In the Matter of: Entergy Nuclear Operations, Inc.
(Indian Point Nuclear Generating Units 2 and 3)

Westinghouse Methodology
for Evaluating the
Acceptability of
Baffle-Former-Barrel
Bolting Distributions Under
Faulted Load Conditions

**SUBJECT: SAFETY EVALUATION OF TOPICAL REPORT WCAP-15029
"WESTINGHOUSE METHODOLOGY FOR EVALUATING THE
ACCEPTABILITY OF BAFFLE-FORMER-BARREL BOLTING DISTRIBUTIONS
UNDER FAULTED LOAD CONDITIONS" (TAC NO. MA1152)**

SAFETY EVALUATION BY THE OFFICE OF NUCLEAR REACTOR REGULATION
WCAP-15029, "WESTINGHOUSE METHODOLOGY FOR EVALUATING THE
ACCEPTABILITY OF BAFFLE-FORMER-BARREL BOLTING DISTRIBUTIONS UNDER
FAULTED LOAD CONDITIONS"

Figure 2-1 Seismic/LOCA Analysis Approach for Determining Acceptable Baffle - Barrel - Bolting

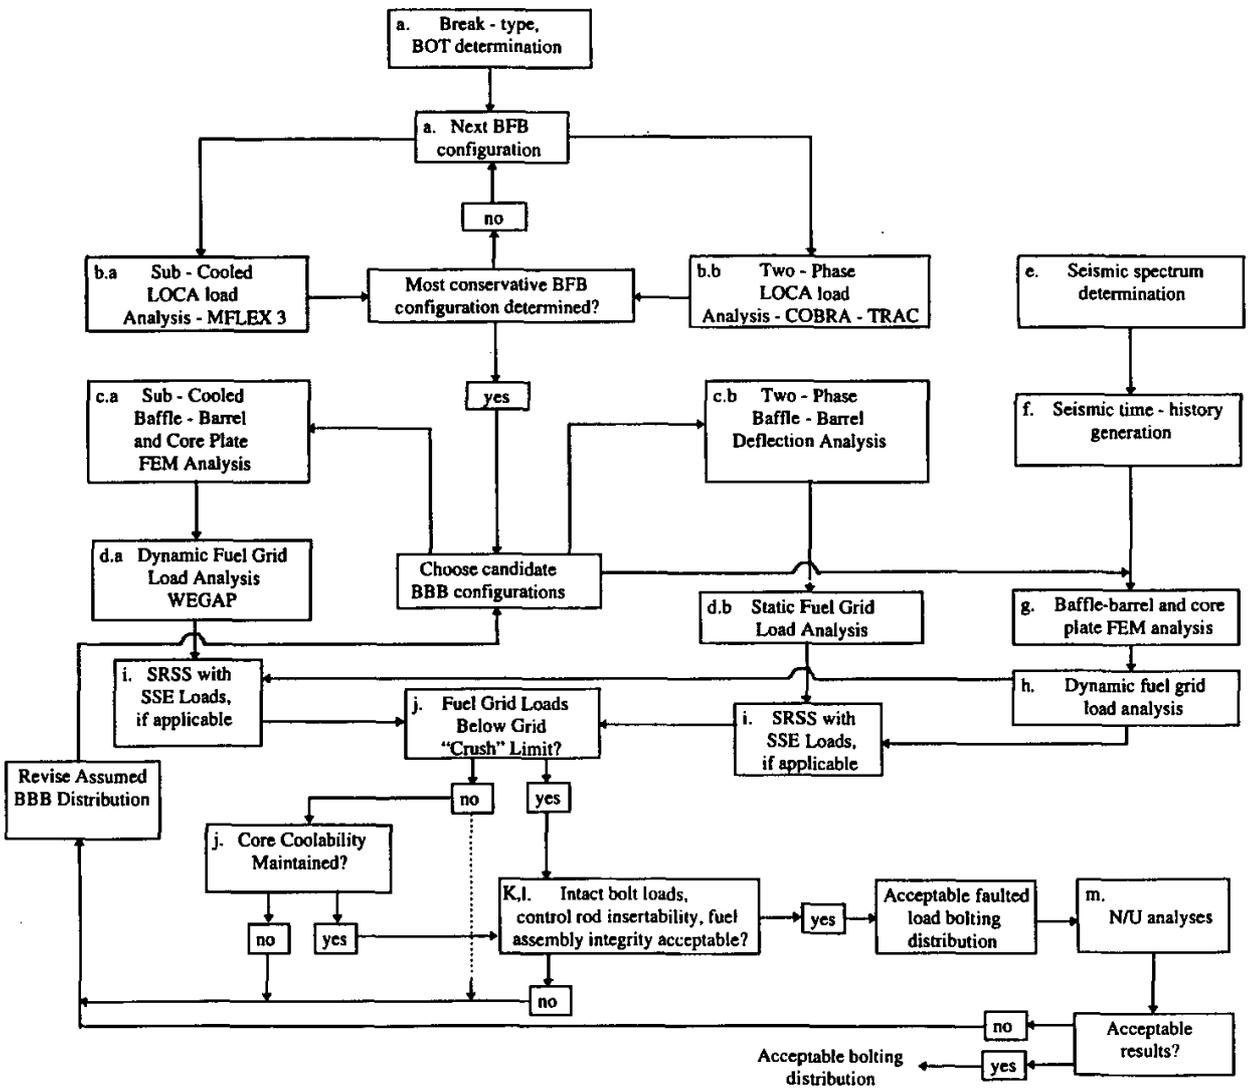
The logic of the methodology depicted in the WCAP-15029 flow chart is an appropriate process for evaluating acceptable bolting loads and distributions. The *Multiflex 3.0* program is described as a more sophisticated analysis tool for LOCA hydraulic force calculations than the currently

1. The bolt loading should be determined by analysis for a class of plants and a specific break;
2. The noding to be used in the representation of the loading is demonstrated to be adequate by performing nodalization sensitivity studies or by some other acceptable methodology;
3. The methodology should not be used to assess existing bolting without demonstration of adequate conservatism in projected bolting material properties (i.e., yield and ultimate strength) to ensure that sufficient ductility is present in existing irradiated stainless steel bolting materials;
4. The use of the methodology for existing irradiated stainless steel bolting should account for limitations in available ISI methods with regard to the probability of detection characteristics;
